Record of Executive Business and Chief Executive's Order

Reg. Reference: SDZ21A/0023

Submission Type: Additional
Information

Proposed Development:

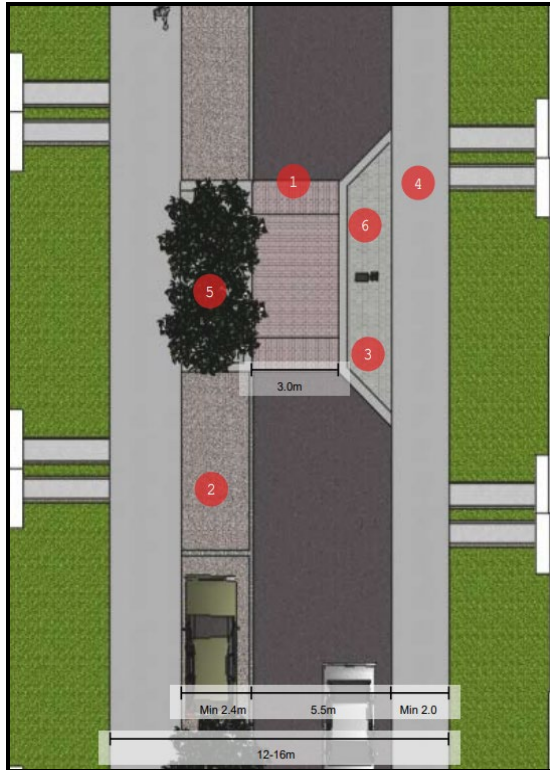
From the layout plan, there appears to be two types of secondary streets – a car based street and a homezone. It is not clear how these streets align with the ASCG hierarchy. The below shows indicative layouts for side streets and back streets:

The applicant is requested to provide a road layout plan clearly indicating street typologies. Each type of street should meet the relevant design requirements in terms of parking, pedestrian/cycle movement, crossings and street trees. **Additional information** is required. It is noted that some perpendicular parking associated with the secondary streets is visible from the avenues – the applicant is requested to redesign these areas via **additional information**.

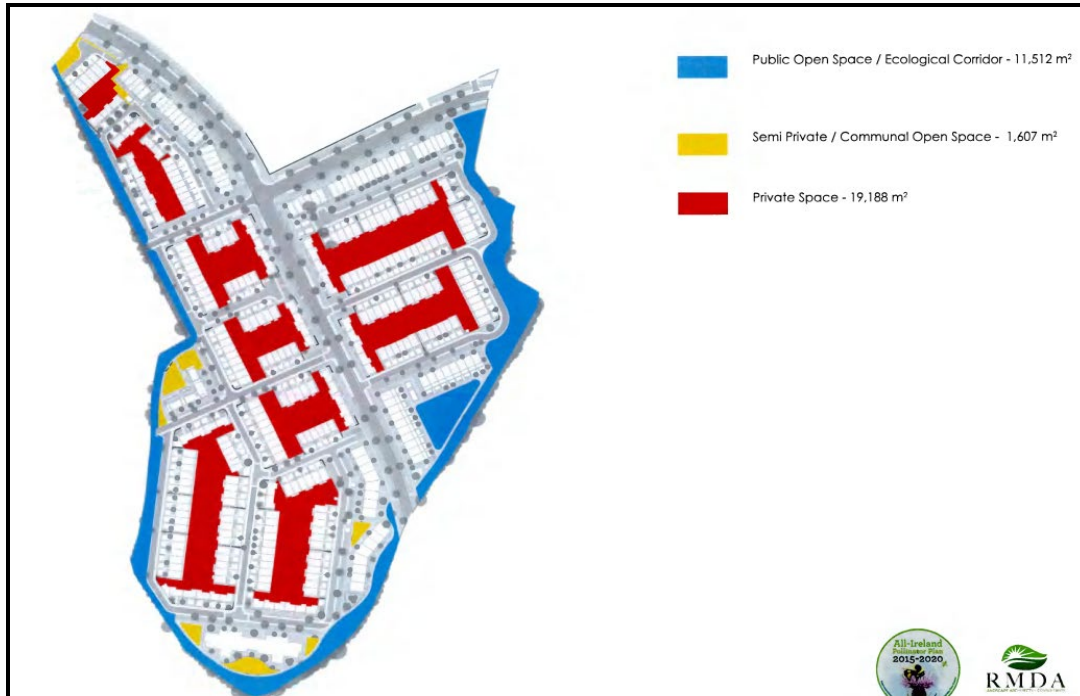
The proposed development would provide long sections of boundary treatments with blank facades in some instances. This is seen on section 1. It is noted that the sections are generally along the Avenues, with the exception of Section 1, which enters one of the secondary streets. The Planning Authority has detailed a number of units that would benefit from dual frontages. The provision of dual frontage would reduce the impact of the boundary treatments in these areas. The applicant is requested to provide revised sections of the smaller streets via **additional information.**

Figure 2 road layout from SDZ17A/0009

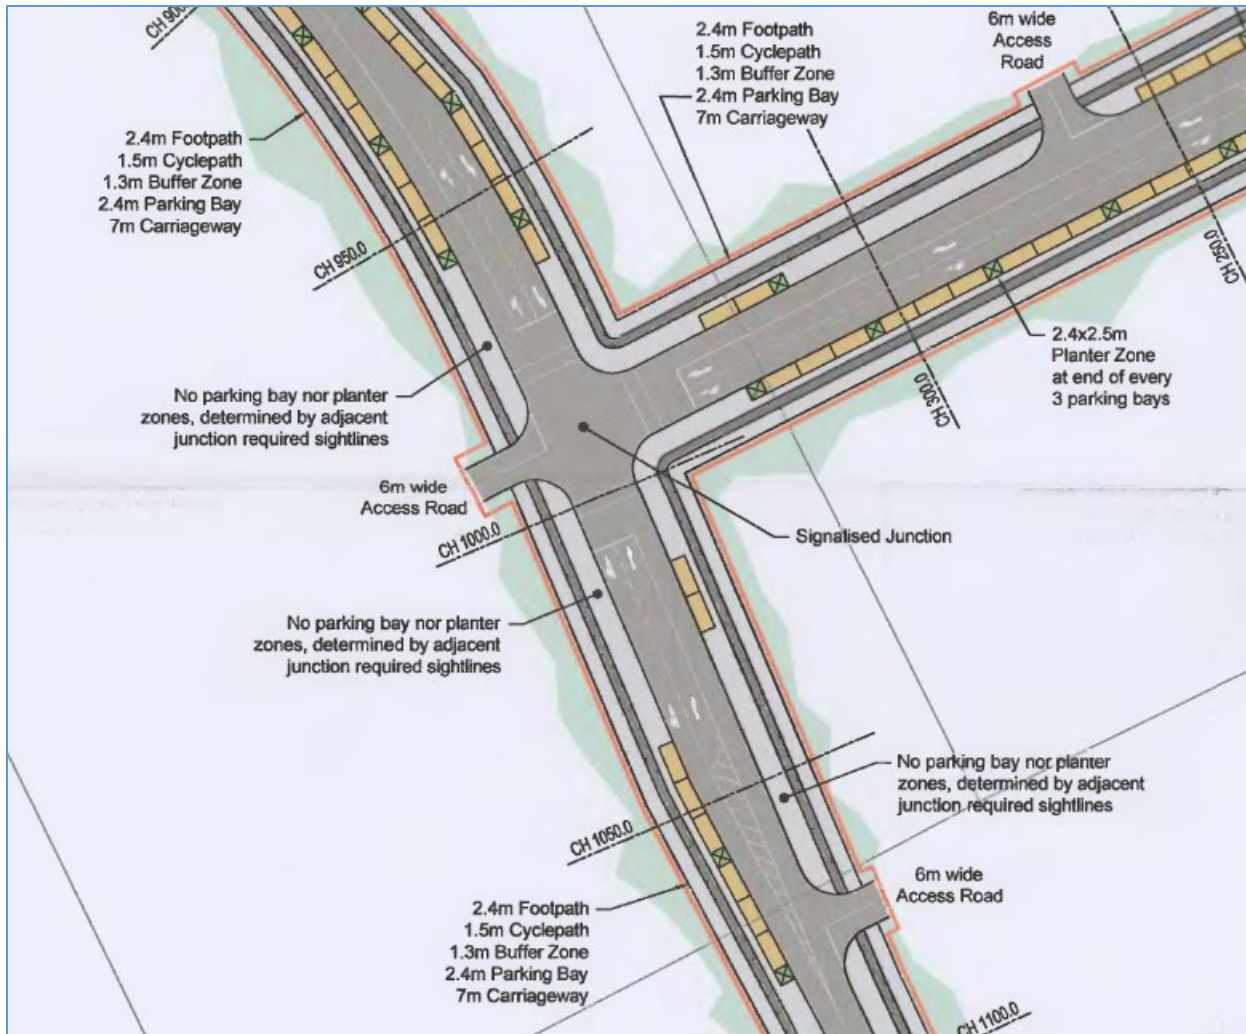
1. Internal Road Layout

The internal road layout has been provided. The applicant should provide the road cross sections for each road type and ensure the design of roads and streets within the Adamstown SDZ are in accordance with DMURS. Cross section for each road type should ensure correct spacing for cycle lanes and parallel and perpendicular parking. The details of access roads and crossing points should also be submitted showing dimensions of corner radii, road widths etc.

Figure 4 link to west development.

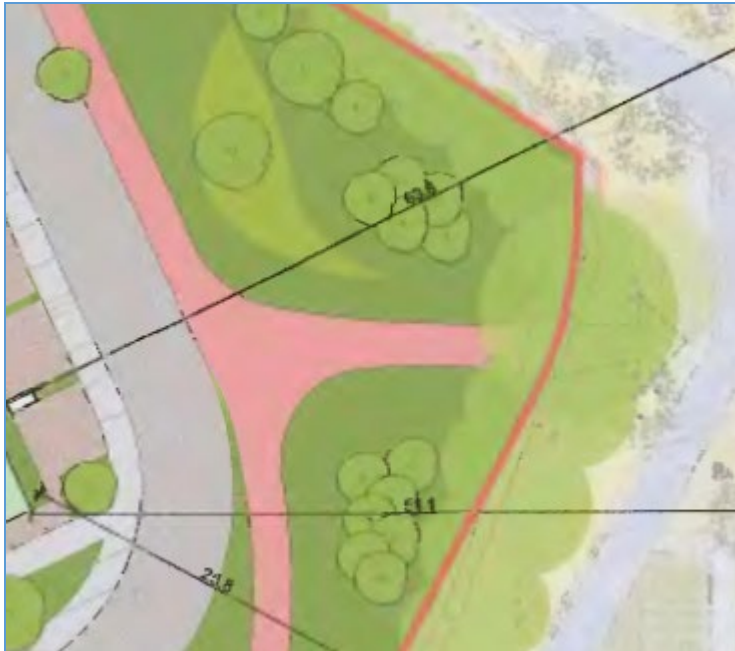
The link to the east Figure 4, is shown as pedestrian this is vehicular in the SDZ tile. This is a link to the proposed school and shopping to the west of the development and crosses the linear park. This link should be verified and match the proposed link from the neighbouring development.

Figure 8 Bike shelter

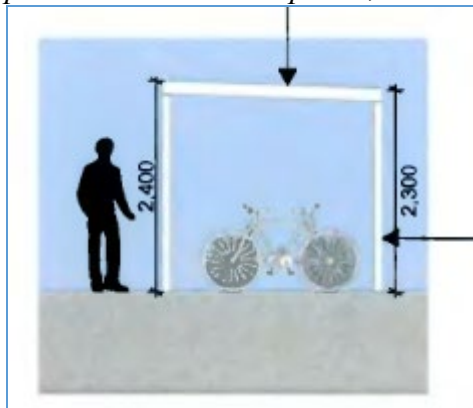
Details of bicycle parking shelters has been provided, Figure 8. The location of the shelters has also been provided. The applicant should provide a statement on the quantity of bicycle parking provided at the development, to ensure the amount is consistent with the apartment guidelines.

Figure 9 Taking in Charge map

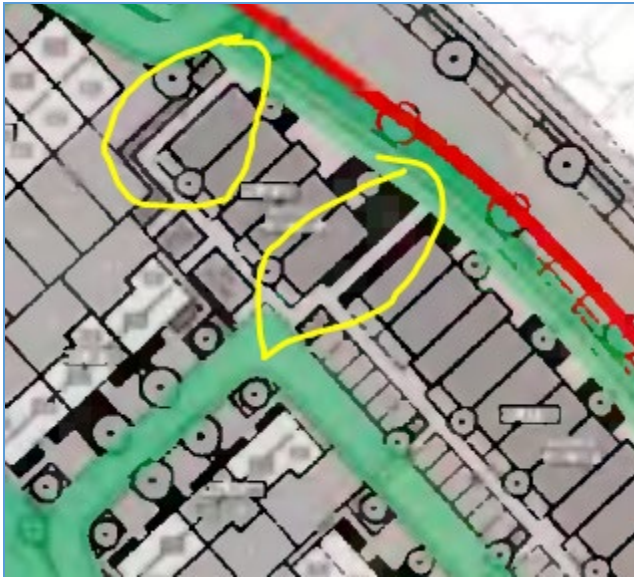
A taking in charge drawing has been submitted detailing the areas for public care. All the parking spaces and apartment areas are to be maintained by management company. The submitted map highlights the areas for Taking in Charge in green. Figure 9 below shows footpath links (highlighted) are not to be offered for Taking in Charge, this could be clarified.

Figure 10 Updated RMDA communal open space diagram

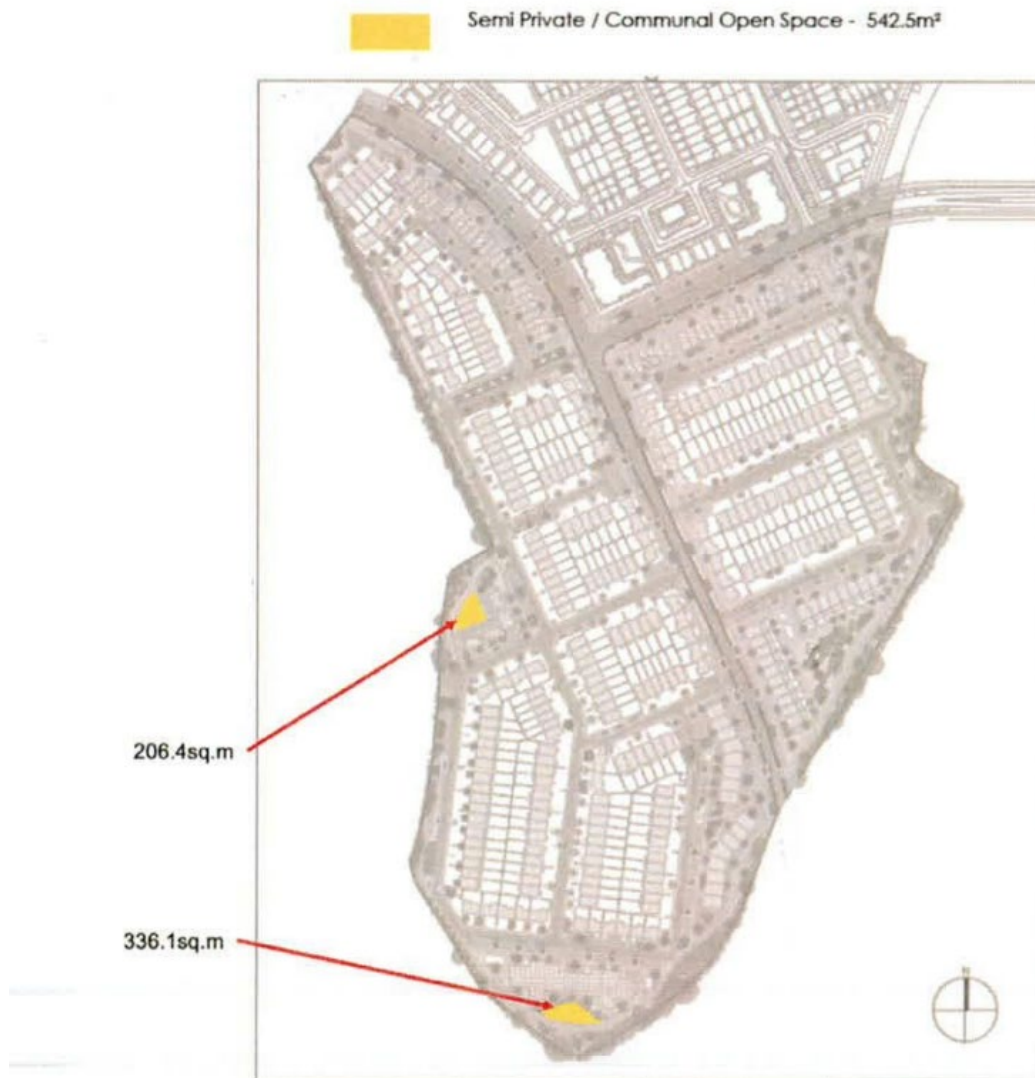
(A) The applicant is requested to provide a breakdown of the communal amenity space and how it accords with the apartment guidelines.

4. (A) 542.5sq.m of communal amenity provided at 2 locations. Communal space includes only functional. Requirement under apartment guidelines is 384sq.m.

Figure 3: Public Open Space calculation (extract)

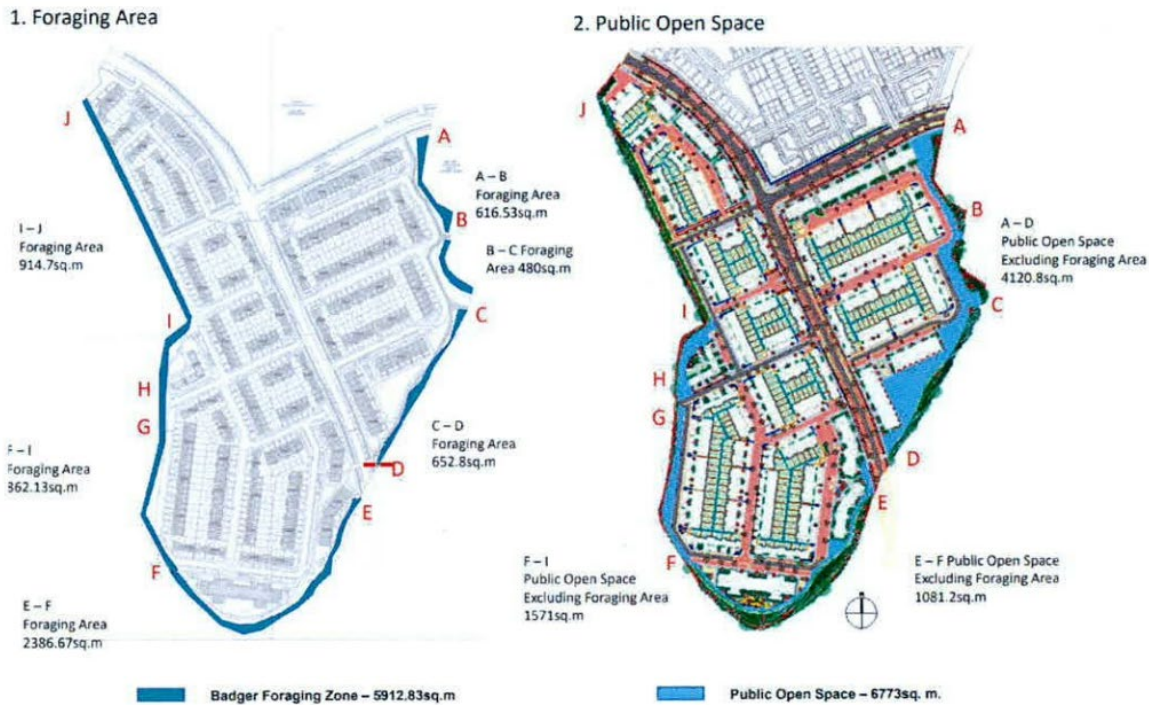
- a) *There is only one small area of public open space for the entire development, i.e. a pocket park in the southeast of approximately 0.2ha or 2% of the development. Development Area 5 is required to provide 0.67 hectares of Public Open space. The applicant is required to demonstrate that this has been provided. The Landscape Rationale includes areas in the public open space calculation that cannot be considered as public open space, i.e.:*

(4) total POS is 0.677ha
